Review ‘How to measure the efficiency of terrestrial carbon dioxide removal methods’

Reviewer 1: Wei Li

Reviewer 2: Irina Melnikova

Fig. 1: Modeled and observed yields. Observed yields with fertilization and irrigation are highlighted in yellow, fertilization but no irrigation in red, no fertilization but irrigation in blue and neither in gray.

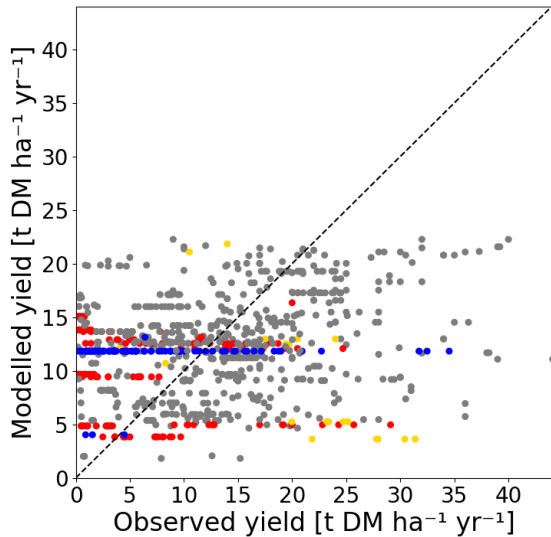
14. Section 2.4: would it make more sense to either put this section to supplementary together with Figs. 2 and 3, or make a more thorough analysis by dividing all the sites to three categories: best match, large underestimation, large overestimation sites (in Fig 3a)? Is it related to irrigation or fertilization? Does the mismatch have any implications on this study’s conclusions?

Response: As discussed, the mismatch is partly due to the different spatial resolutions of models and observations. We find that the mismatch is not related to fertilization or irrigation (see Fig. 1; see also Li et al. 2018, Fig. S6 / S7 and Littleton et al. 2020, who compared their HBP implementations against the same observational dataset). Note that in Fig. 1, we show a comparison of single sites rather than averaging over a grid cell as in the paper. Thus, several observations that are located in the same grid cell correspond to a similar modeled yield. We conclude that the global mean is reproduced fairly well, whereas regional and small-scale differences are biased.

We decided to keep the model evaluation in the main text because we provide the first peer-reviewed paper that shows the model implementation of HBPs in JSBACH3.2.
